**Item:** Montana Federal Credit Union – 15 14<sup>th</sup> Street South

**Action Requested:** Approve the submitted design with conditions.

## Design Review Board Narrative

**ADDITION: RENDERING & MATERIALS**

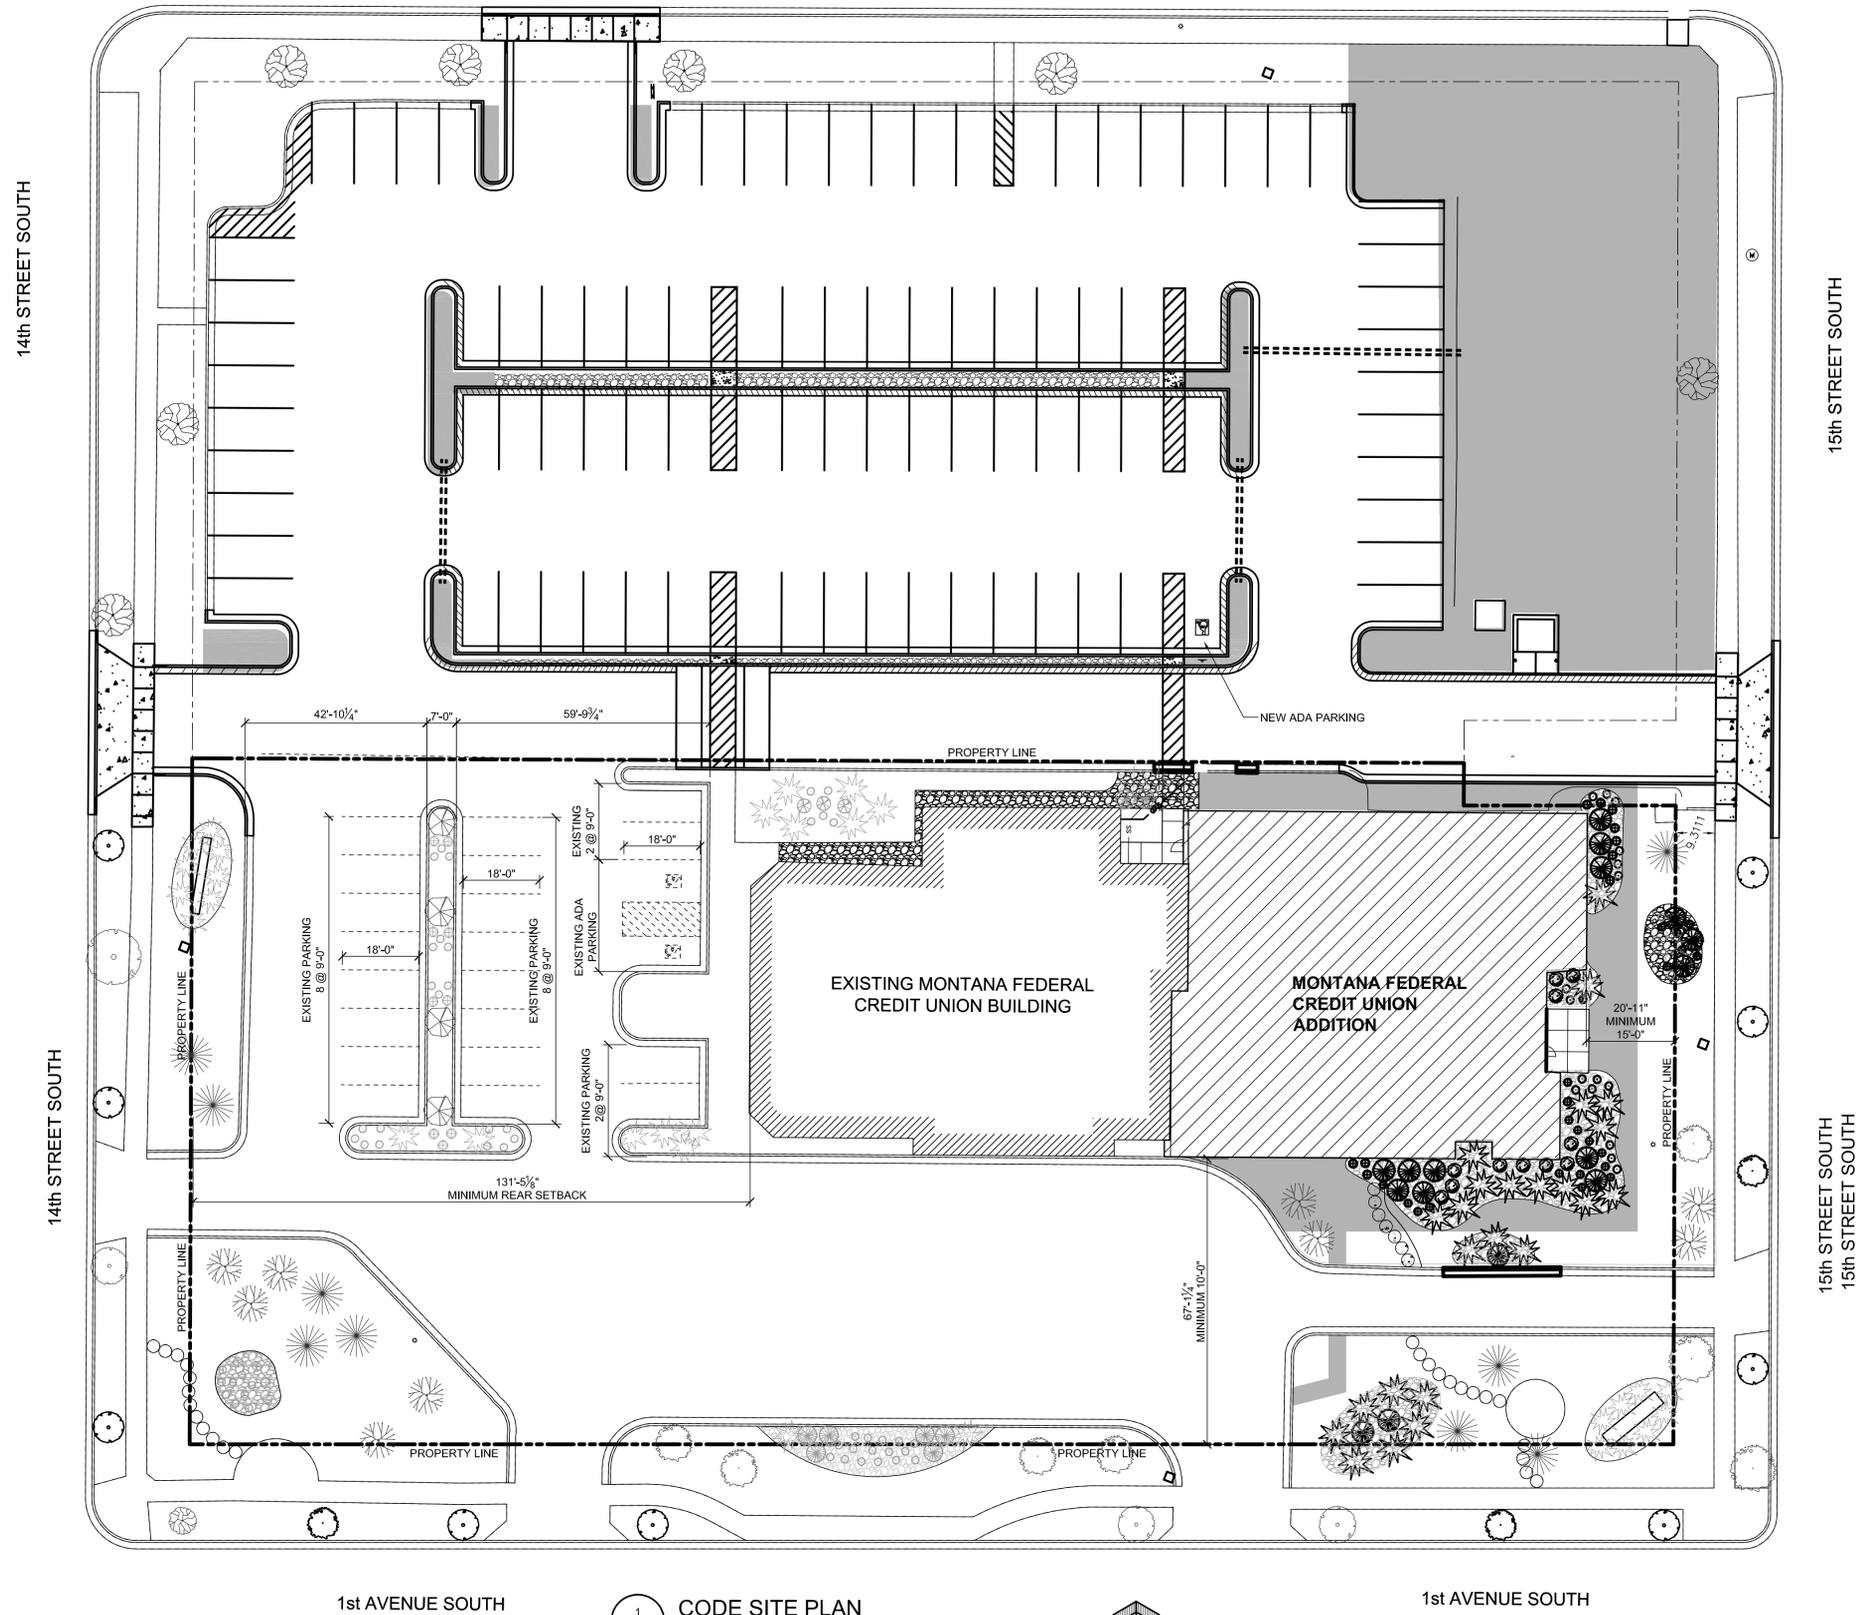
The proposal is in compliance with all requirements of Exhibit 28-1. One guideline, dealing with signage, states that signs should consist of materials and colors that are similar to and compliment the primary structure. It should be noted that the color scheme of the proposed

signage is bold and varies from the neutral colors of the existing and proposed buildings. This includes the proposed awnings near the front façade entrance. These can be seen in the attached renderings. Staff does recognize the boldness of the color scheme and its departure from Guideline 24. However, staff is ultimately fine with the design because the bold color signage and awnings are a small part of the overall building. The two-story expansion is proposed with a contemporary design containing a gabled roof with asphalt shingles as well as a flat roof. The addition is proposed with a simple yet classic design. The exterior materials will consist of stone and EIFS. The building will be constructed with neutral colors that match the existing building such as Wheat and Sage Bend, and more vibrant accent colors with shades of purple and blue. The design of the proposed building will help to deter the monotony of identical treatments, while the exterior materials will convey permanence, stability, maintainability, and long life. A full color and material palette can be found in the attached color renderings and elevations.

LANDSCAPE PLAN  
1"=20'-0"  
NORTH REF

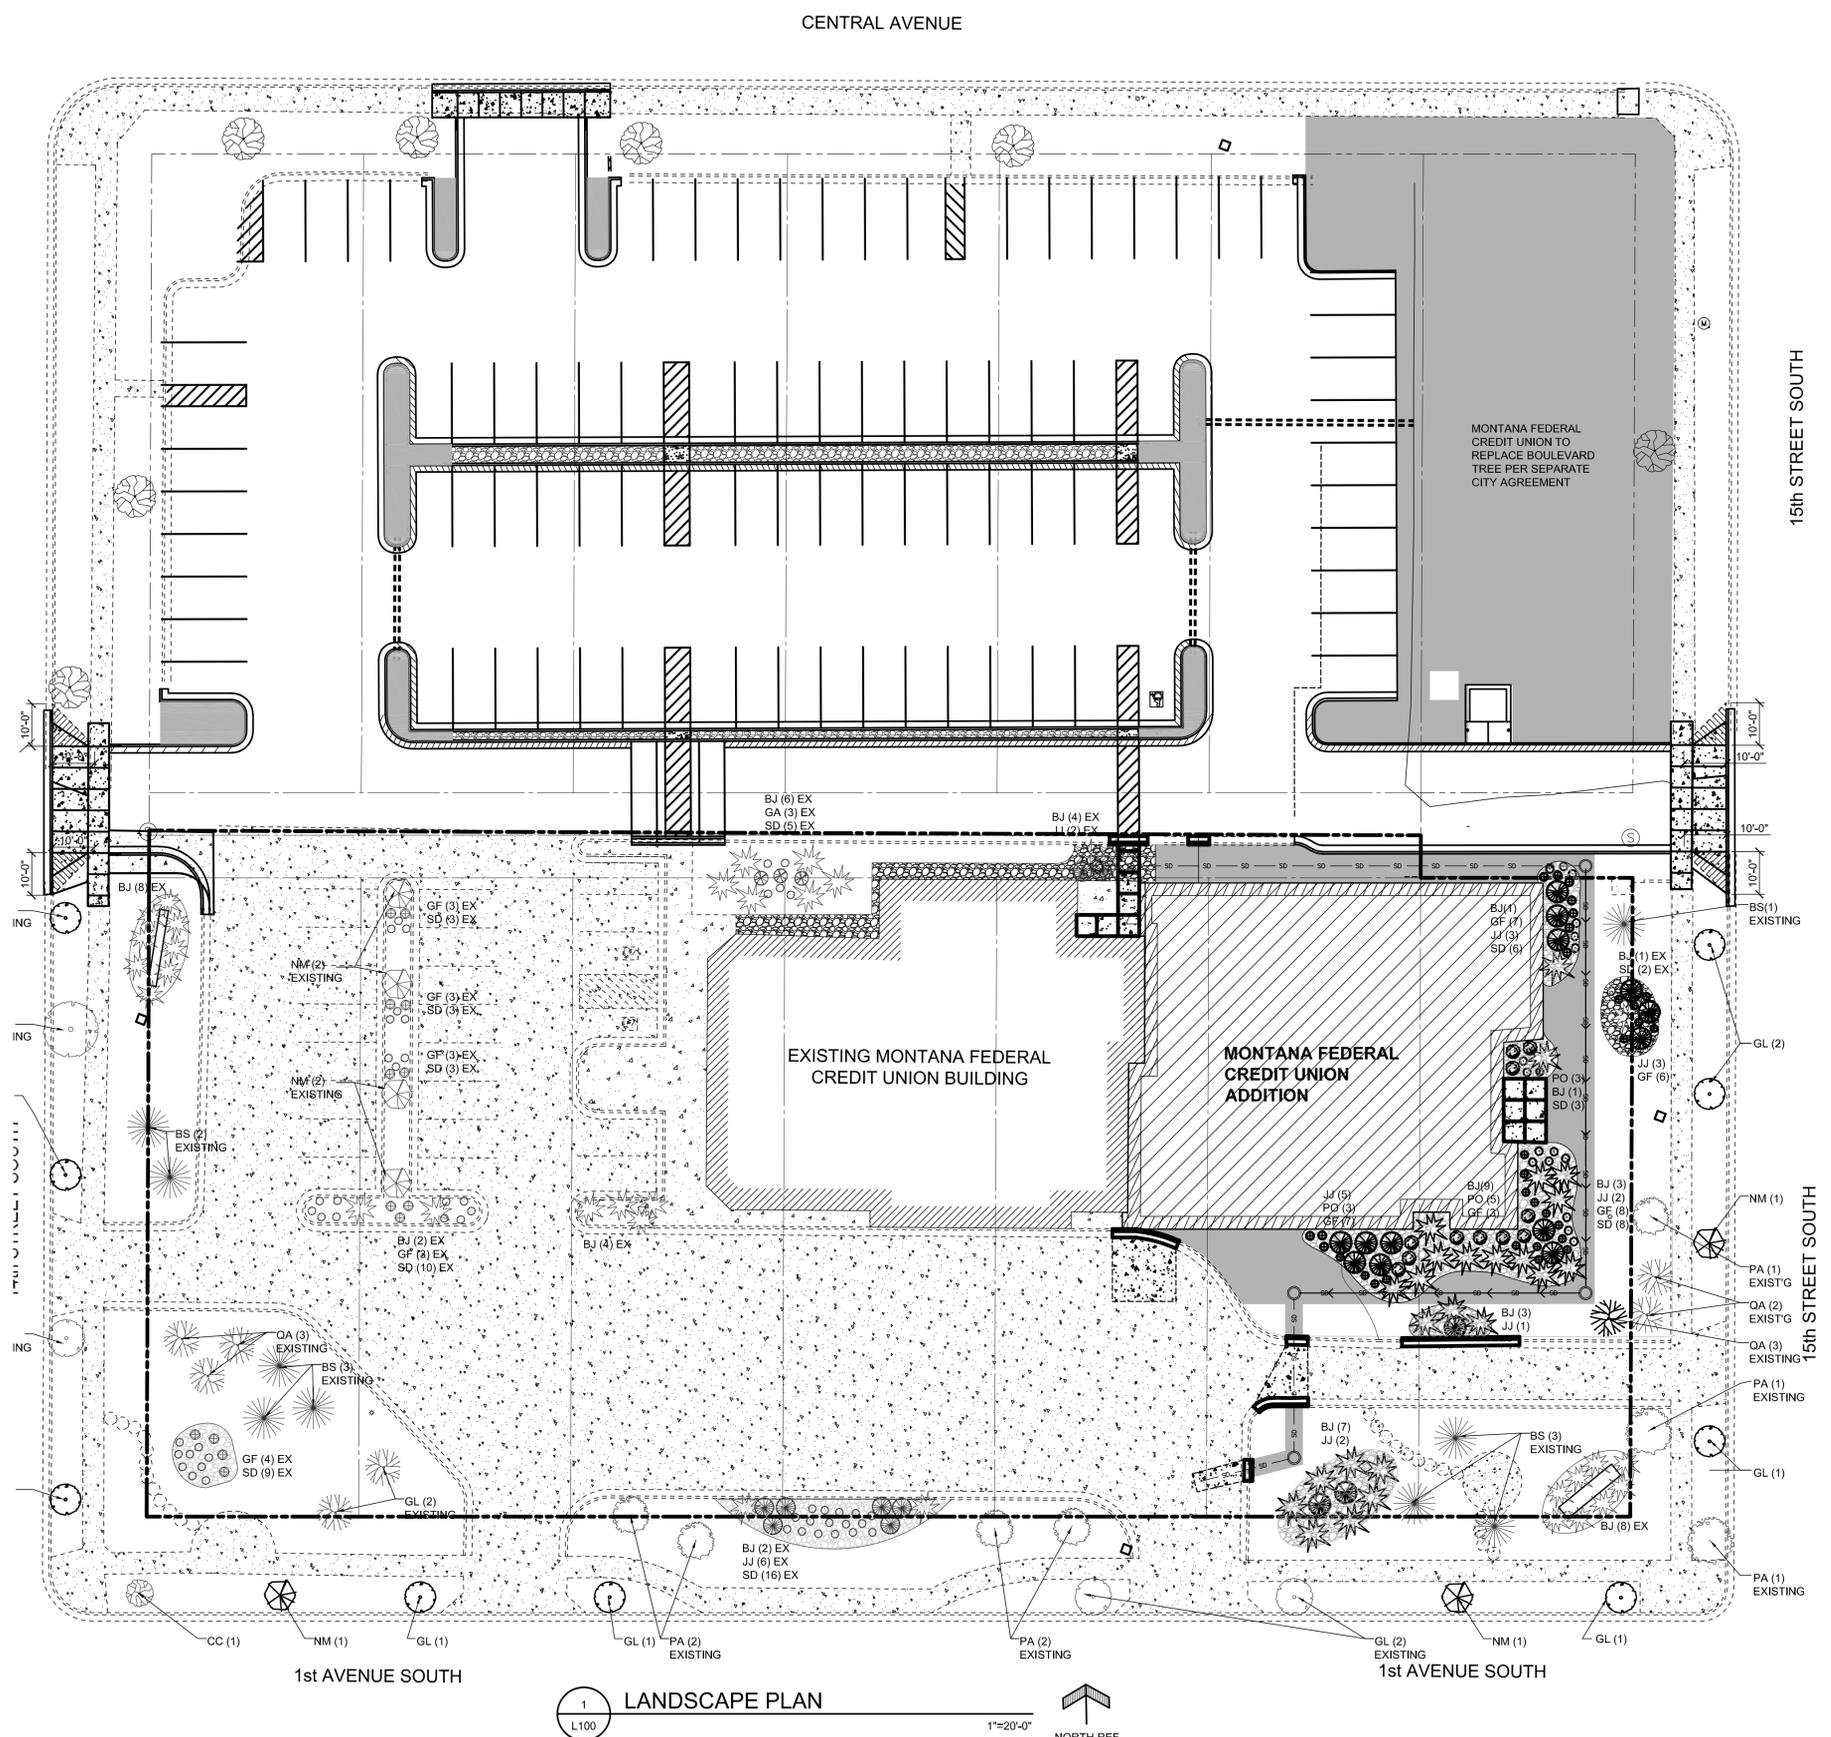
The proposed landscaping is in compliance with the minimum requirements of the OCCGF. Paved or nonliving surfaces are the dominant texture within the interior of the site, with cement walkways accessing the building from the public right-of-way, an asphalt parking lot, and organic mulch in all landscape beds. The exterior of the site will be significantly improved by landscaping including grass, canopy trees, shrubs, and perennials.

The OCCGF Chapter 44 – Landscaping requires one (1) canopy tree and seven (7) shrubs to be planted and maintained for each four hundred (400) square feet of landscaped area, which is fifteen percent of the gross lot area. For this site, there are already 20 existing interior trees on the property. A total of 137 new shrubs required to be installed. The applicant’s proposal is in compliance with code requirements.

Plan View  
Scale - 1" = 20ft

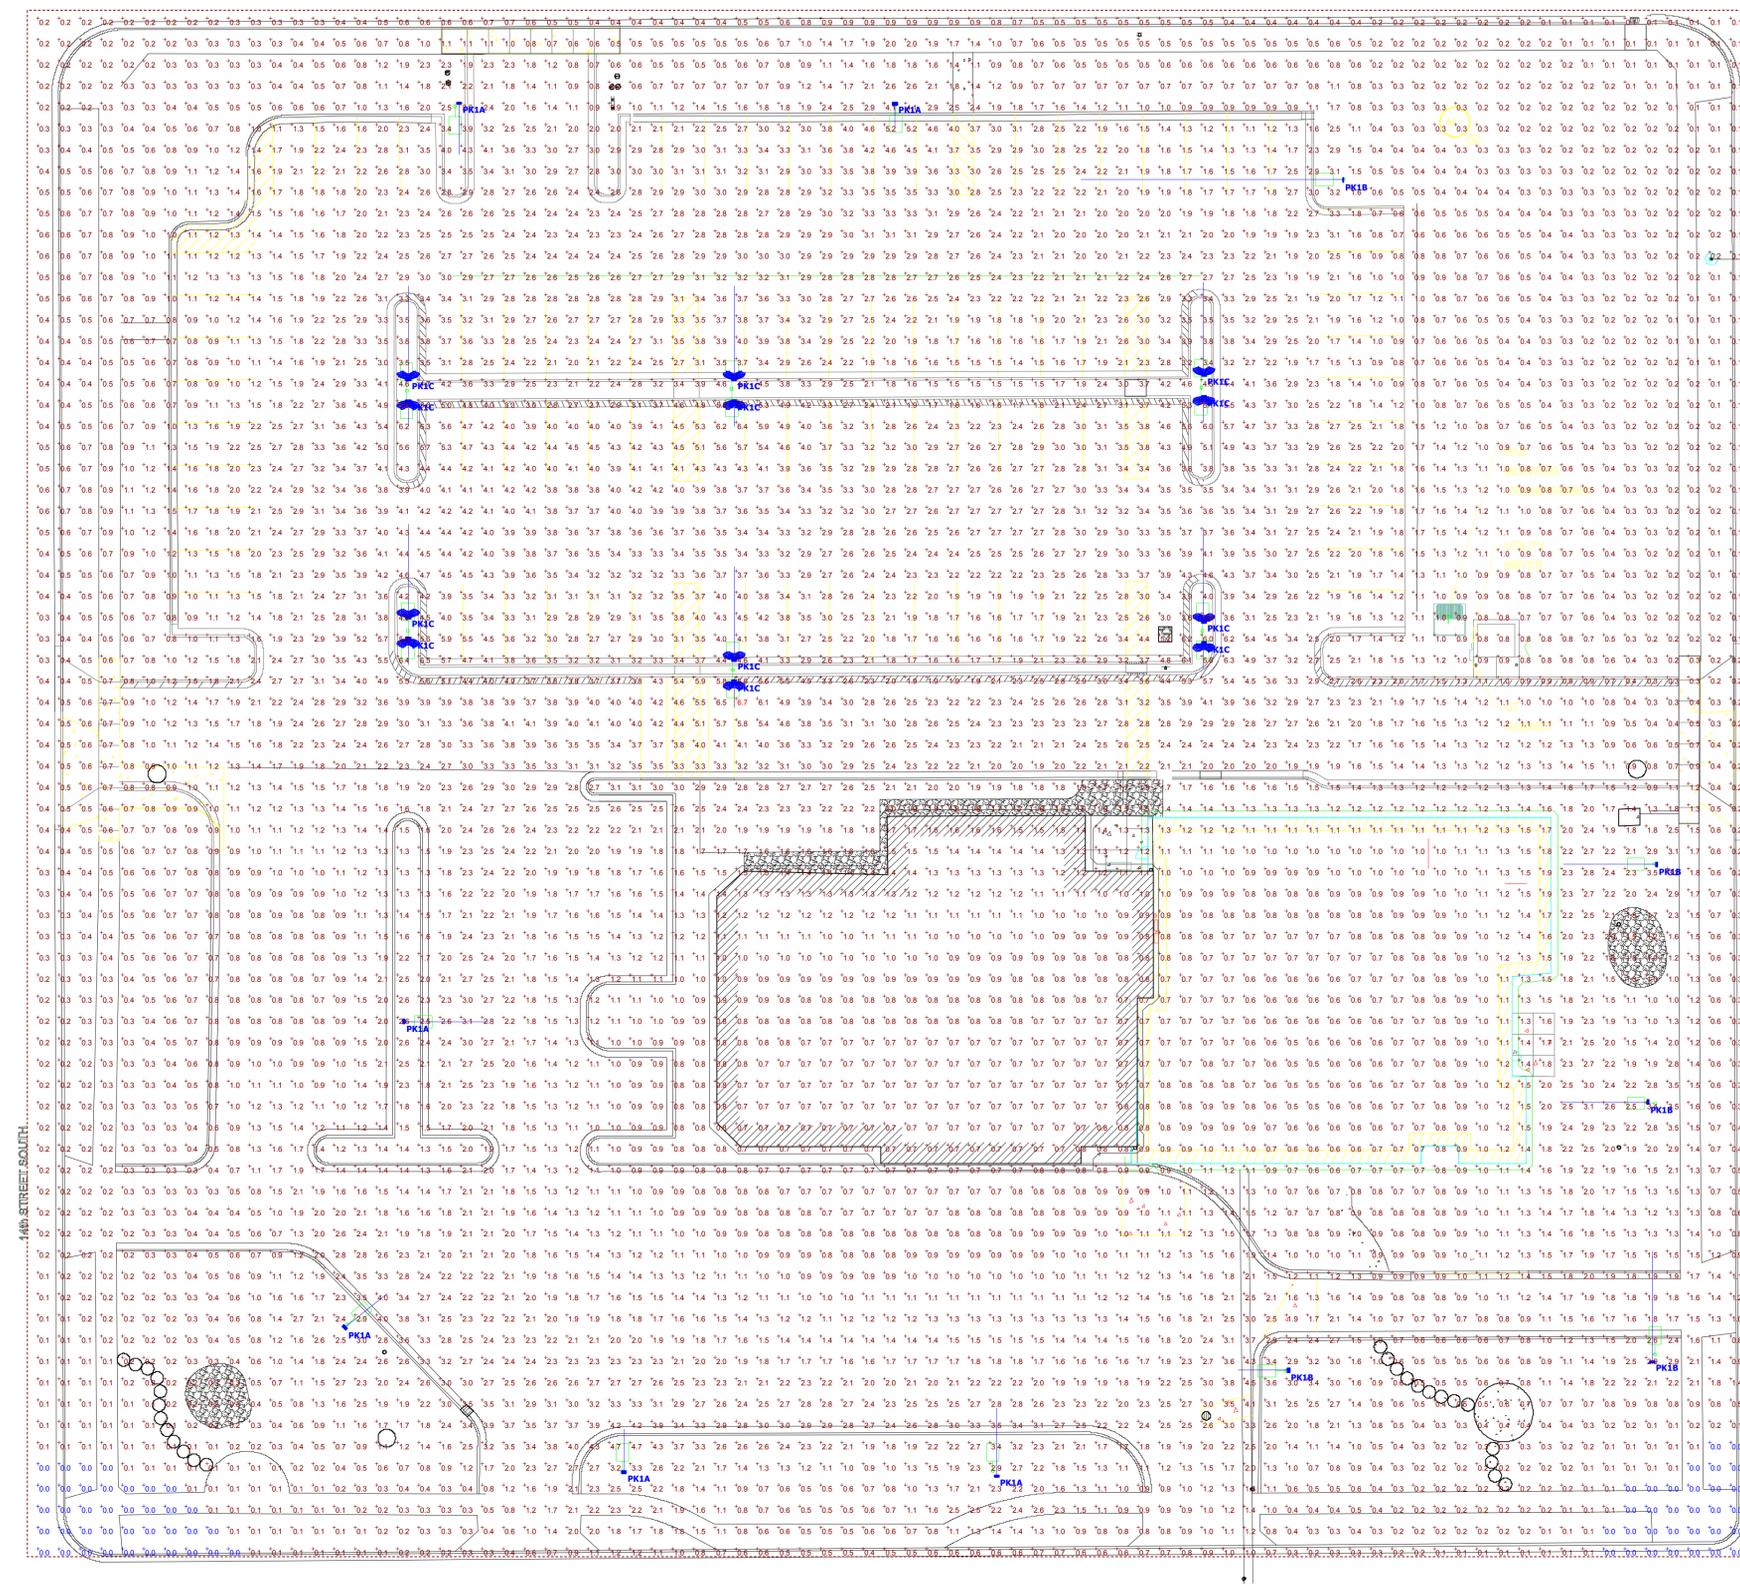
The applicant has provided an outdoor lighting plan which is in compliance with the requirements of Chapter 40 - Outdoor Lighting of the OCCGF. The proposed lighting plan provides lighting mounted on the building and pole-mounted lights in the parking lot. The fixtures are full down cast to prevent light pollution into the surrounding areas.

**TRASH ENCLOSURE ELEVATION**  
SCALE: NOT TO SCALE

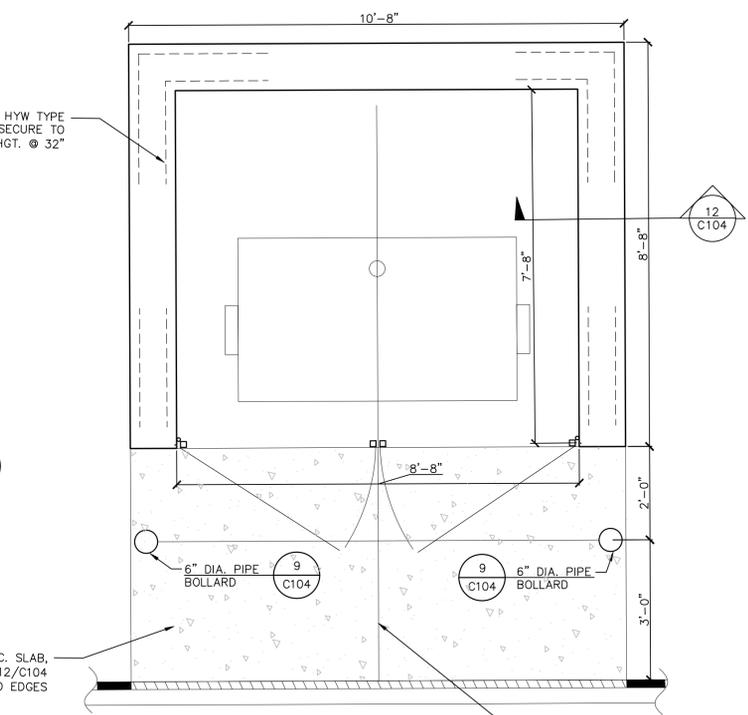
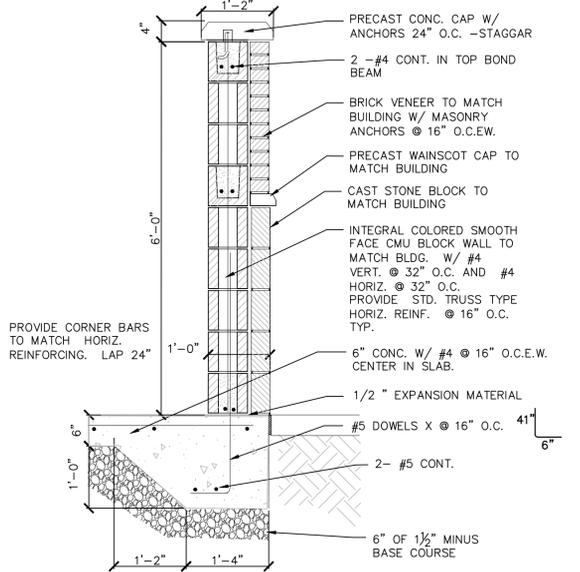
A trash enclosure is located on the adjacent vacant property owned by the applicant. While this is an unusual location choice, it doesn't violate City code. The enclosure is designed to be screened by a six (6) foot high fence, brick veneer, and CMU block wall.
